**BIDS AND AWARDS COMMITTEE FOR INFRASTRUCTURE PROJECTS (BAC-I)**

**BIDDING FOR THE CONSTRUCTION OF 9-STOREY RESIDENTIAL BUILDING IN FORT  
BONIFACIO, TAGUIG CITY**

**BID BULLETIN NO. 4**

This Bid Bulletin clarifies queries received through email from prospective bidders and other matters pertaining to the above Project.

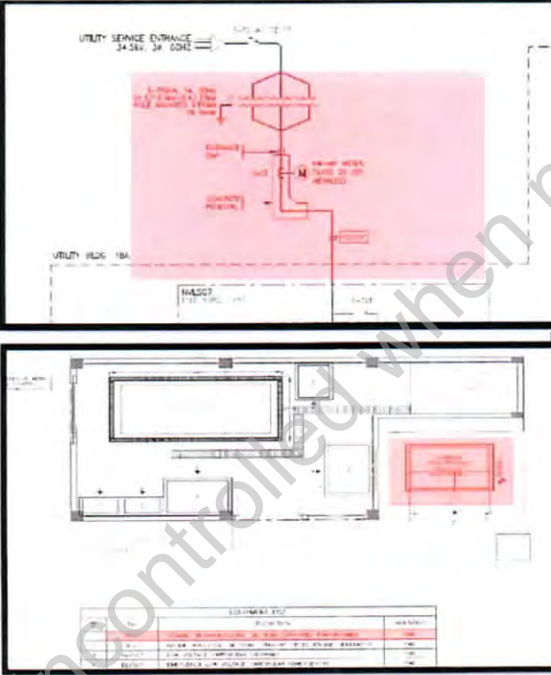
<p>Q24. Drawings - STP The 'Main Index of Drawings CS-1A, CS-1B, CS-1C' indicates Drawings for Bldg. 10.2 – SOQ, Bldg. 18 – Pump House, Bldg. 18A – Utility Block, and Bldg. 18D2 Utility Block. Drawing CS-1. Please indicate the area/structure for construction (see screenshot) which show STP:</p>	<p>STP is part of Contractor's scope and the Contractor shall hire a specialty STP technology provider based on the given Performance Specification.  For the performance specification of the STP, please refer to Section 02750 Sewage Treatment Plant Performance Specification of the Plumbing and Sanitary Technical Specifications.  For the BOQ, please refer to item 1001 (20).</p>

<p>Please advise if STP (civil + MEPFs) is part of scope. If yes, requesting for the drawings of the STP. Please note that, there are no drawings of the STP and it is not mentioned at BOQ.</p>	NO.	DESCRIPTION	DATE	BY	CHECKED	SCALE	SHEET NO.	TOTAL SHEETS	1	CONSTRUCTION OF HOUSING FACILITY IN FORT BONIFACIO															
NO.	DESCRIPTION	DATE	BY	CHECKED	SCALE	SHEET NO.	TOTAL SHEETS																		
1	CONSTRUCTION OF HOUSING FACILITY IN FORT BONIFACIO																								
<p>Q25. Please provide the sheet of Schedule A.1 as indicated to BOQ, <b>'Item no. A.1.1 (3)a: Field Office with Pantry and Toilet (Four (4) units 40-footer container van in Rental Basis) . Note: to include Schedule A.1'</b></p>	<p>Please refer to the General Requirements Specifications for the description of items under Schedules A.1, A.2, B, C, D, E.1, E.2, and F.</p>																								
<p>Q26. Please provide the sheet of Schedule A.2 as indicated in BOQ <b>'Item no. A. 1. 1 ( 10): Living Quarters for the Engineer (One 40-footer container in Rental Basis. Note: to include Schedule A.2'</b></p>	<p>Please refer to the General Requirements Specifications for the description of items under Schedules A.1, A.2, B, C, D, E.1, E.2, and F.</p>																								
<p>Q27. Please provide the sheet Schedule B per BOQ, <b>'Item no. A.1.1 ( 11): Provision of Furniture, Fixtures, Office Equipment and Appliances for the Field Office and Living Quarters (Schedule B)'</b></p>	<p>Please refer to the General Requirements Specifications for the description of items under Schedules A.1, A.2, B, C, D, E.1, E.2, and F.</p>																								
<p>Q28. Please provide the sheet of Schedule C sheet as indicated to BOQ, <b>'Item no. A.1.1 (4) : Provision of Office Supplies and</b></p>	<p>Please refer to the General Requirements Specifications for the</p>
